Lot 107

New Home Construction Application

Physical Address: 1066 Hidden Shore DR.

FRONT ELEVATION 1/8 in = 1 ft

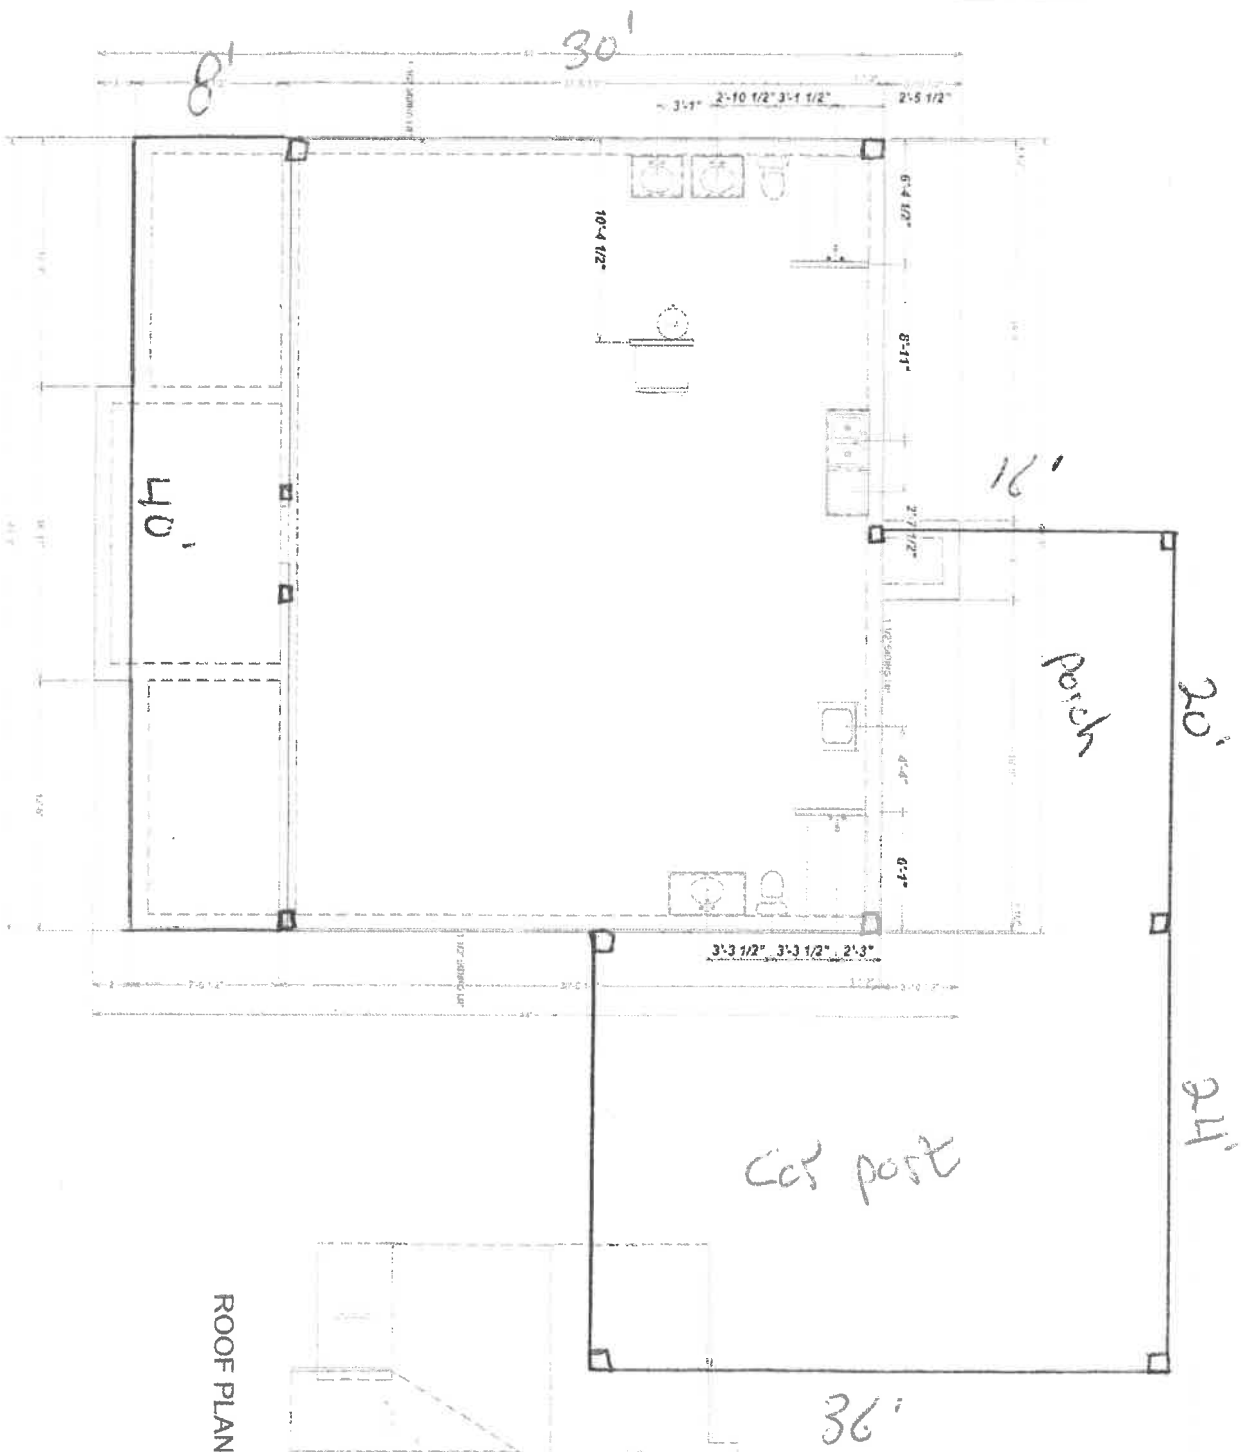
No gable ON front porch
